**SAFETY
RECALL**

Sr99-20A

DATE : April 1999	SECTION : 16 SUSPENSION
SUBJECT : LOCK WASHERS ON SWAY BAR U-BOLT

HEIGHT CONTROL VALVE LEVER ATTACHED TO SWAY BAR, NOT RADIUS ROD

FIGURE 1 : HEIGHT CONTROL VALVE ON INDEPENDANT SUSPENSION

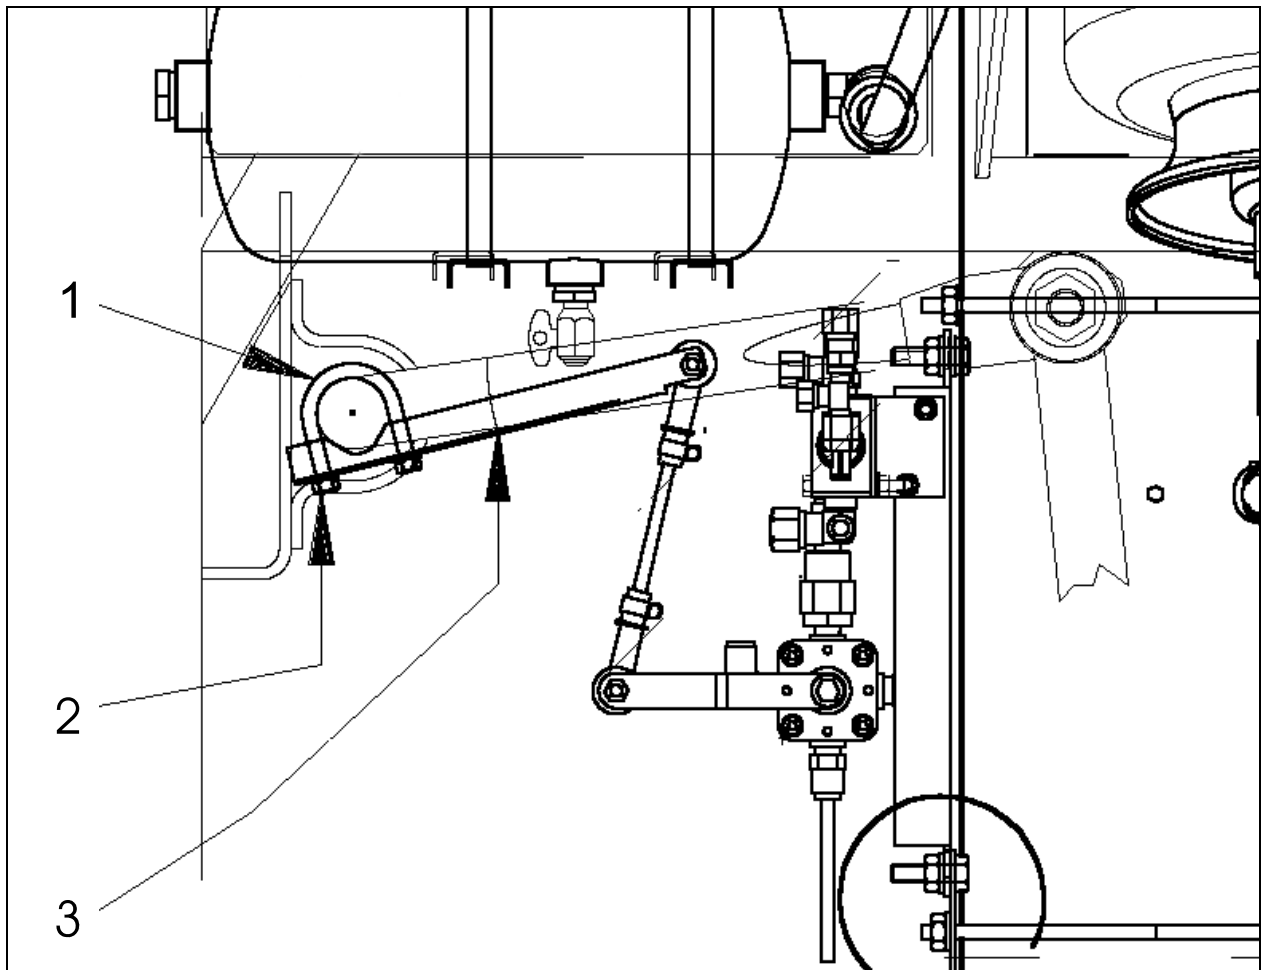
On the vehicles mentioned above, the height control valve lever attached to the sway bar of the independent front suspension may have been fastened without using lock washers. Prévost Car Inc. believes that the fasteners may loosen over time, resulting in improper suspension height adjustment and possible loss of vehicle control. To repair this defect, two lock washers must be installed on the U-bolt retaining the height control valve lever.

1. Locate the front suspension height control valve lever (3, Fig. 1) and U-bolt (1, Fig. 1).
2. To keep the levelling system properly adjusted, mark the position of the valve lever on the sway bar. Place a lock washer and tighten the nut one stud at a time (2, Fig. 1).

Part No.	Description	Qty
500476	Lock Washer, zinc plated, .317 x .586 x .078	2
